PCN# : P632AAB
Issue Date : Apr. 01, 2016

Information Only Notification

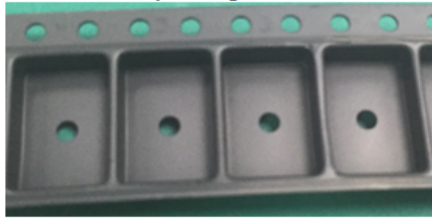
TO252 devices packed by standard carrier tape without stop bar in cavity.

TO263 devices packed by standard carrier tape without corrugated and emboss design.

TO252 devices packed by carrier tape with stop bar in cavity.(FSZD-4-0023)

TO263 devices packed by carrier tape with corrugated and emboss design.(FSZD-4-0024)

Key dimension "F" and "P1" are not affected.

TO252: Adding a stop bar to prevent lead pierce through carrier tape during product transportation.

TO263: The change is to mitigate carrier tape deformation which result in lead bent during product transportation.
